E7515A-01C

Modification Recommended Service Note

E7515A UXM Wireless Test Set

Modify the Embedded PC to improve boot reliability.

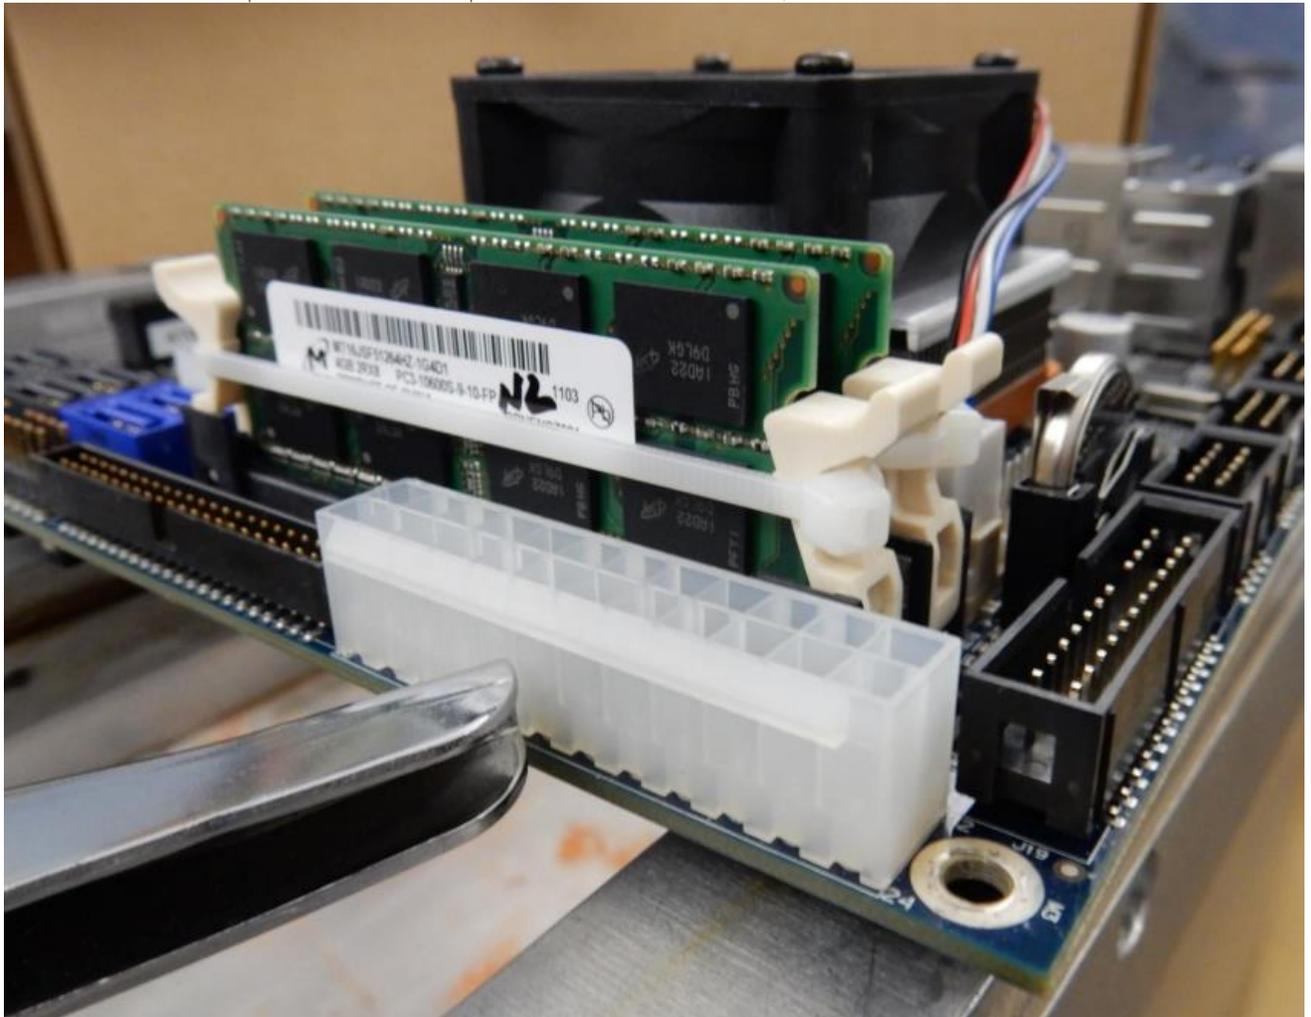
The E7515A will fail to boot if either of the RAM modules on the Embedded PC are not fully engaged in the memory slots or if the gold plating on the RAM modules has been damaged during transportation shock and vibration.

A design change from MY5716xxxx onwards was implemented to improve the UXM boot reliability by changing RAM module supplier and changing the locking mechanism used to hold the RAM modules in place.

1. Remove the outer covers from the instrument
2. Remove the Front Panel to fully inspect the RAM modules on the Embedded PC.
3. Replace the failing **SwissBit** or **Samsung** DRAM with **Micron** RAM part number - 1819-1185.
NOTE: You may need to cut away Glue or RTV holding the existing memory in place.

- Secure the RAM in place with ESD Zip Ties - 1400-0482 or equivalent

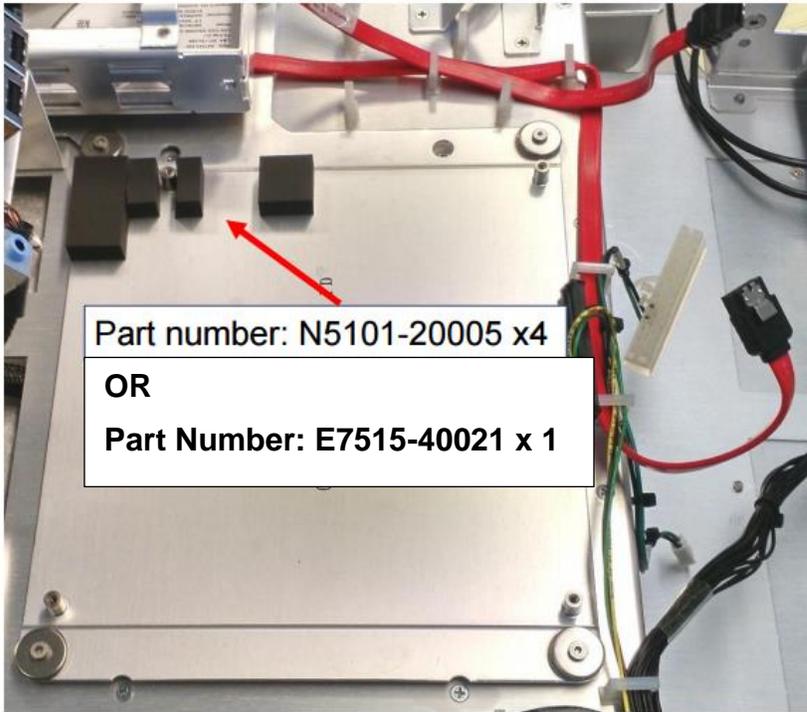
Extra padding was also added to the underside of the Embedded PC to further dampen the vibration and improve the boot reliability after transportation vibration.

5. Inspect the underside of the Embedded PC and add 4x N5101-20005 or 1x E7515-40021 if not already installed.

NOTE: If not using E7515-40021 you will need cut one square padding in half to straddle the standoff

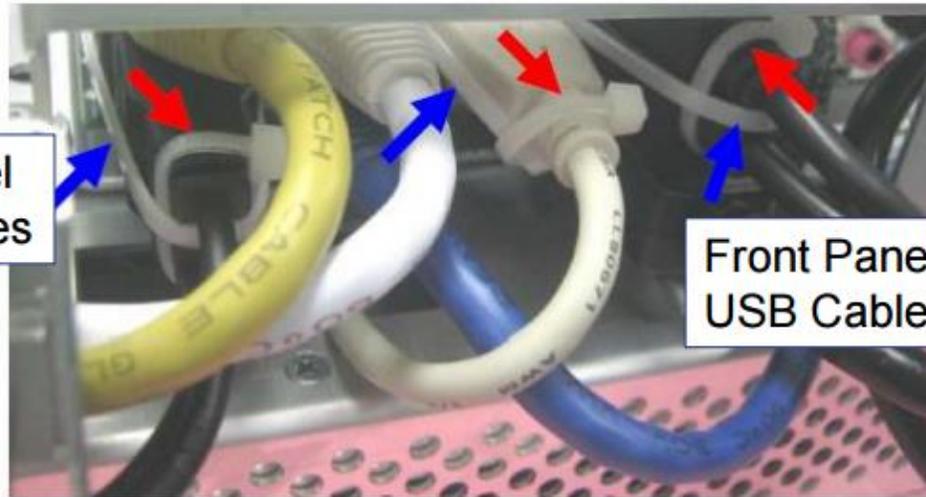
6. Re-install the Embedded PC and attach cables. Add cable ties, 1400-3557, to the USB Cables

Touchscreen USB Cable (white)

Rear Panel USB Cables

Front Panel USB Cables
